Form 3160-5
(June 2019)UNITED STATES
DEPARTMENT OF THE INTERIOR
BUREAU OF LAND MANAGEMENTFORM APPROVED
OMB No. 1004-0137
Expires: October 31, 2021**SUNDRY NOTICES AND REPORTS ON WELLS**
Do not use this form for proposals to drill or to re-enter an abandoned well. Use Form 3160-3 (APD) for such proposals.

8. Well Name and No. HAWK 35 FED/401H

EOG respectfully requests an amendment to our approved APD for this well to reflect the following changes:

Hawk 35 Fed 509H (FKA 401H) API #: 30-025-48030

WELL LOCATION AND ACREAGE DEDICATION PLAT

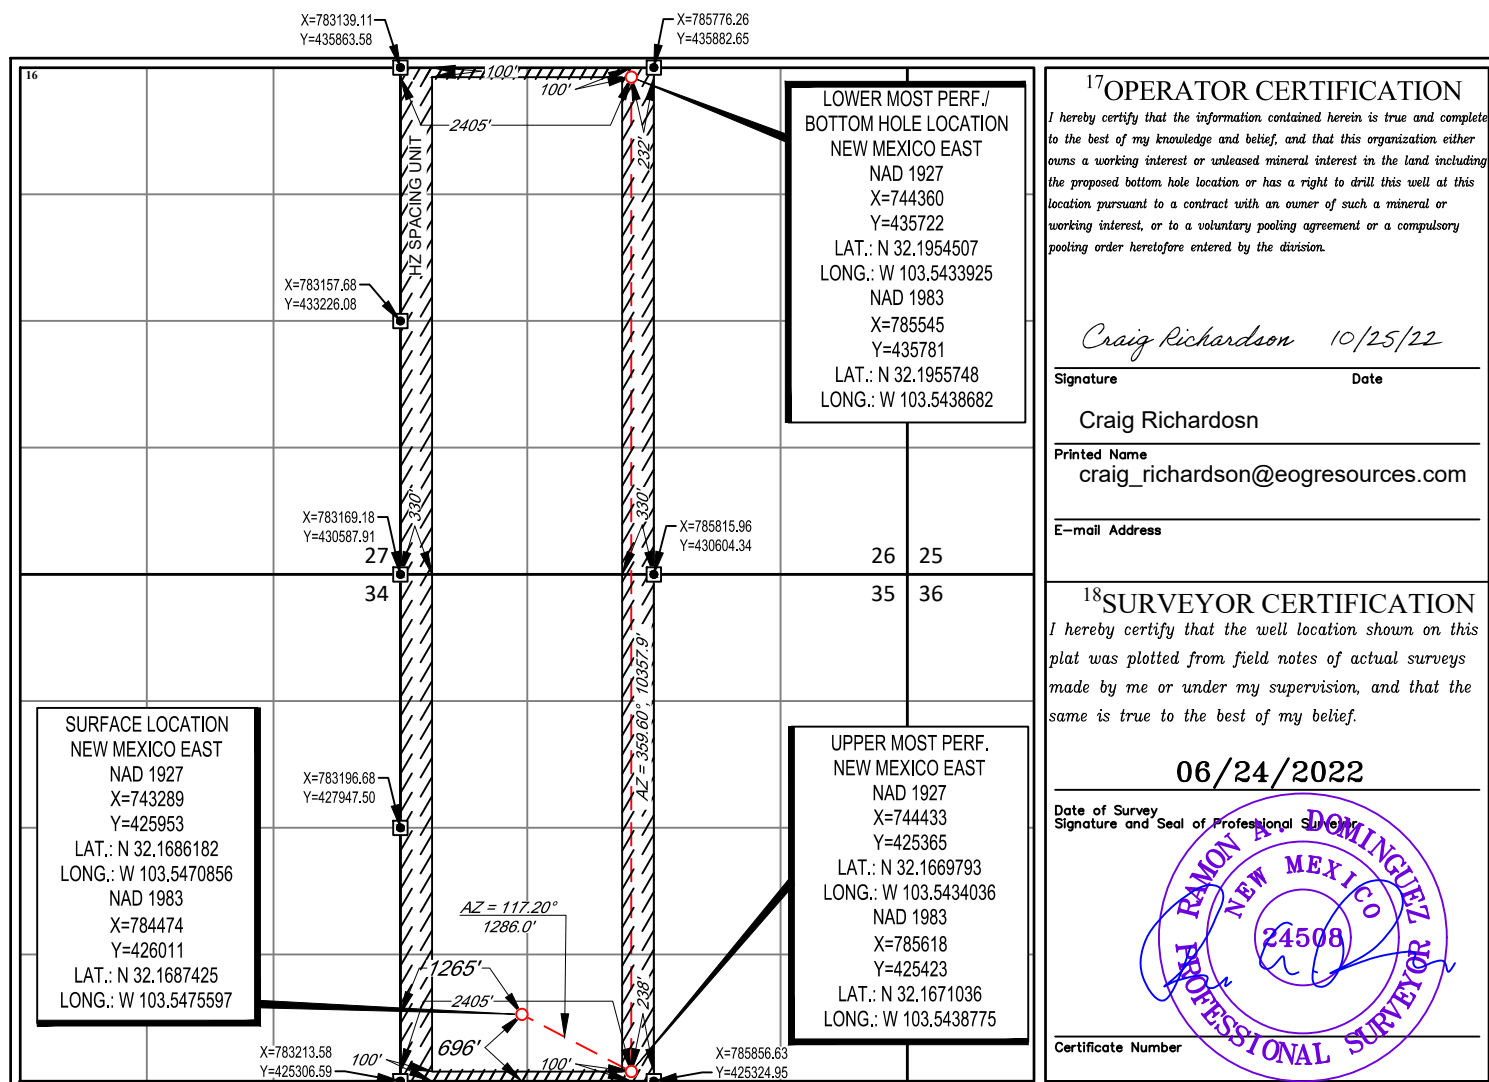
Change name from Hawk 35 Fed 401H to Hawk 35 Fed 509H.

Change BHL from T-24-S, R-33-E, Sec 26, 100' FNL, 660' FWL, Lea Co., NM,
to T-24-S, R-33-E, Sec 26, 100' FNL, 2405' FWL, Lea Co., N.M.

Change target formation to Second Bone Spring Sand.

UL or lot no.	Section	Township	Range	Lot Idn	Feet from the	North/South line	Feet from the	East/West line	County
C	26	24-S	33-E	—	100'	NORTH	2405'	WEST	LEA
